## HISTORIC AND DESIGN REVIEW COMMISSION

Agenda Item No: 11

**HDRC CASE NO:** 2017-005  
**ADDRESS:** 415 CEDAR ST  
**LEGAL DESCRIPTION:** NCB 2968 BLK 3 LOT 4  
**ZONING:** RM-4,H,HL  
**CITY COUNCIL DIST.:** 1  
**DISTRICT:** King William Historic District  
**LANDMARK:** Pfeiffer, A - House  
**APPLICANT:** Jim Poteet/Poteet Architects, LP  
**OWNER:** Kate & James Ball  
**TYPE OF WORK:** Construction of a carport, amendment to previously approved materials on rear addition

## PARTIAL FLOOR PLAN: CARPORT

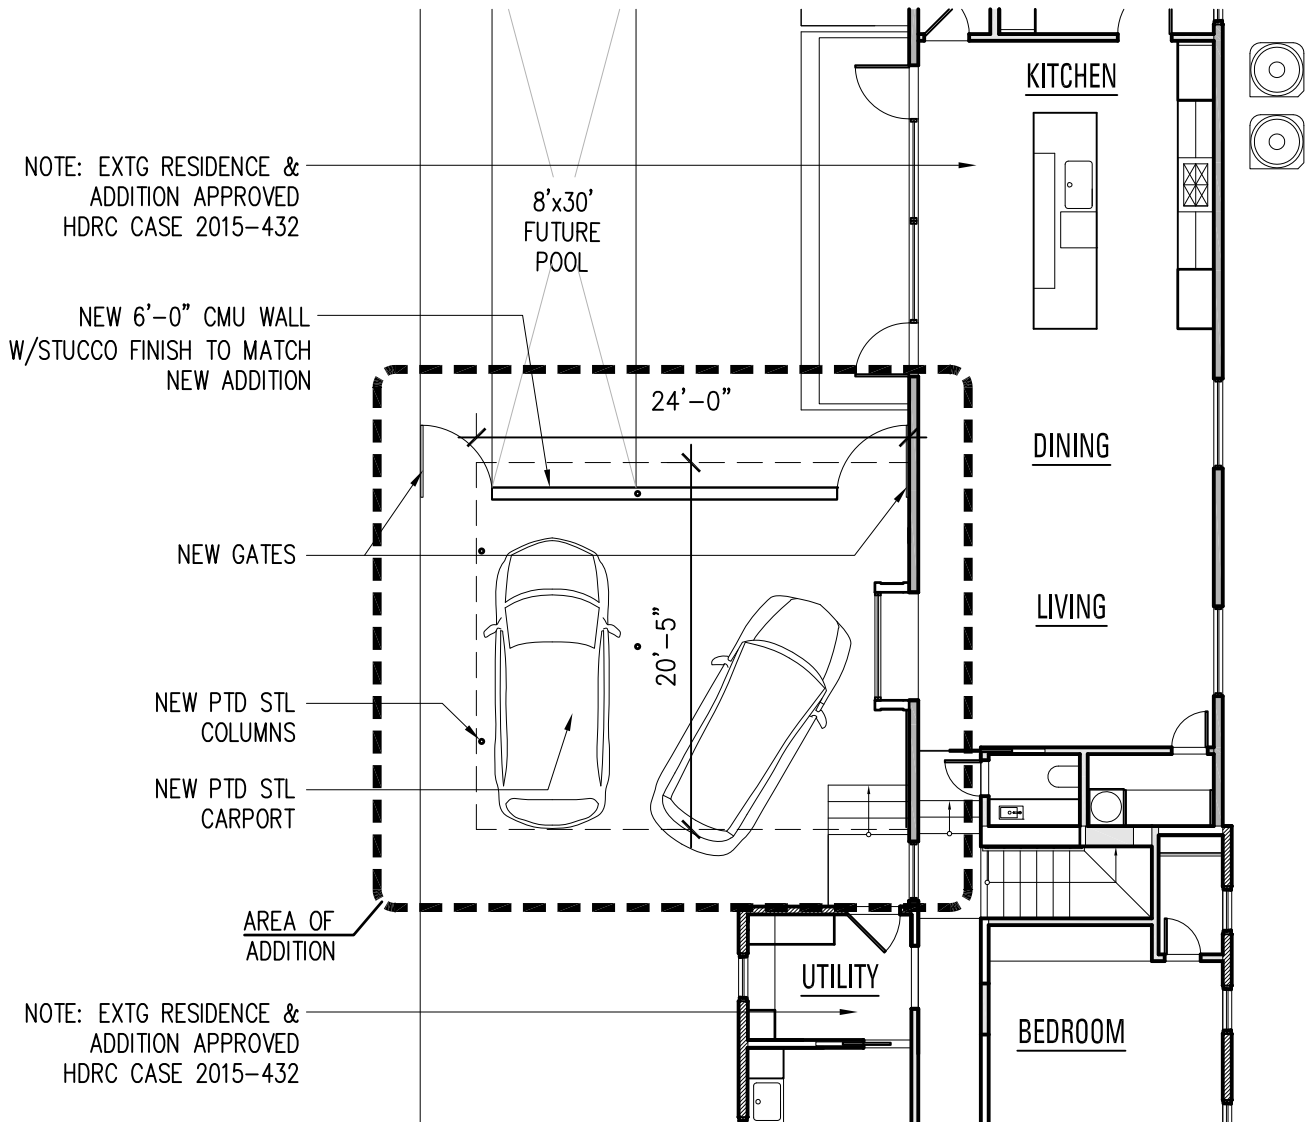
- c. CARPORT – Behind the primary historic structure and beneath the cantilevered area of the rear addition, the applicant has proposed to construct a painted steel canopy. Per the Guidelines for New Construction 5.A., new accessory structures should relate to the period of construction of the principal building on the lot through the use of complementary materials and simplified architectural forms. While steel materials are not historically found throughout the King William Historic District, staff finds that the use of painted steel columns and canopy appropriate given the proposed structure’s transparency, its location to the rear of the primary historic structure and its attachment to a contemporary addition.

- d. TREE REMOVAL – The construction of the proposed carport will require the removal of an existing pecan tree which features a diameter of fourteen (14) inches. Per the UDC Section 35-523, heritage trees are defined as trees featuring a diameter breast height of twenty-four (24) inches or greater. The applicant has noted that the tree is in poor condition. Staff finds the removal of this tree appropriate and eligible to be approved administratively.

Staff recommends approval as submitted based on findings a through d.

## EXTERIOR ELEVATION: EAST

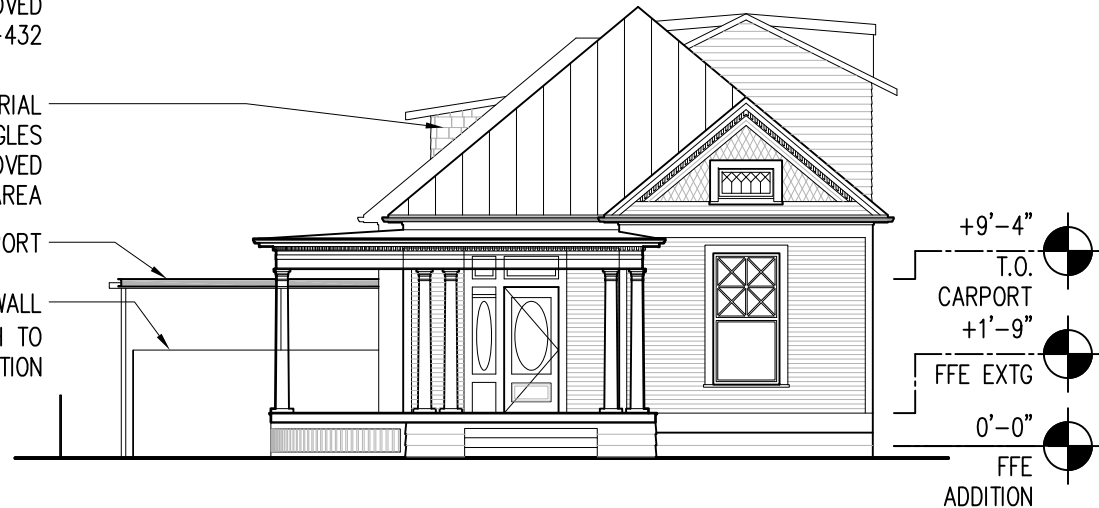
- b. AMENDMENT – At the time, the applicant has proposed to amend the previously approved façade material of wood siding to wood shingle siding on the second level of the rear addition. Per the Guidelines for New Construction 3.A., complementary materials that match the type, color and texture of original materials found in the district should be used. Additionally, alternative uses of traditional materials should also be considered. The primary historic structure features wood shingle siding on the front gable. Staff finds the installation of wood shingles appropriate and consistent with the Guidelines.

- e. CARPORT WALL – To the rear of the proposed carport, the applicant has proposed to construct a concrete masonry unit wall to be covered in stucco to match the materials of the approved addition. The applicant has noted an overall height of six (6) feet and a length of approximately eighteen (18) feet. Staff finds the installation of this wall appropriate and consistent with the Guidelines for Site Elements 2.B.
